OCONEE UNITS 1, 2, & 3

Markup of Attachment III

License Amendment Request

This License Amendment Request proposes changes to the Oconee Technical Specifications, associated Bases, UFSAR, and Core Operating Limits Report (COLR) to implement Topical Report DPC-NE-3005-PA. These proposed changes are dependent upon NRC approval of Revision 1 to DPC-NE-3005-P.

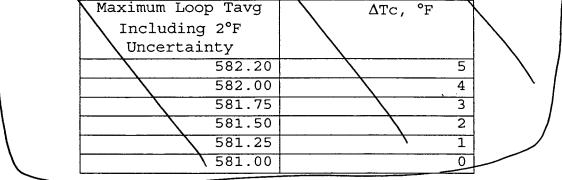
Mark-ups of the UFSAR are provided in Attachment VII. Oconee Unit 2 Cycle 18 will implement the revised UFSAR Chapter 15 non-LOCA analysis methodology of topical report DPC-NE-3005-P, "UFSAR Chapter 15 Transient Analysis Methodology." Revision 0 of this topical report was conditionally approved by the NRC Safety Evaluation Report (SER) dated October 1, 1998. Revision 1 was submitted on February 1, 1999 to respond to the conditions in the SER. The UFSAR Chapter 15 revisions are based on the Revision 1 methodology. Since the methodology is being separately reviewed, and since the analysis results presented follow the methodology, the UFSAR revisions are the implementation of an approved methodology once Revision 1 is approved by the NRC. Many of the results in the UFSAR revisions were already presented in Revisions 0 and 1 of DPC-NE-3005-P.

Δρ/°F		Δρ/°F	
0.90	0	0.700	0
0.00	95	0.030	15
0.00	100	-0.281	95
		-0.300	100
		-0.375	120
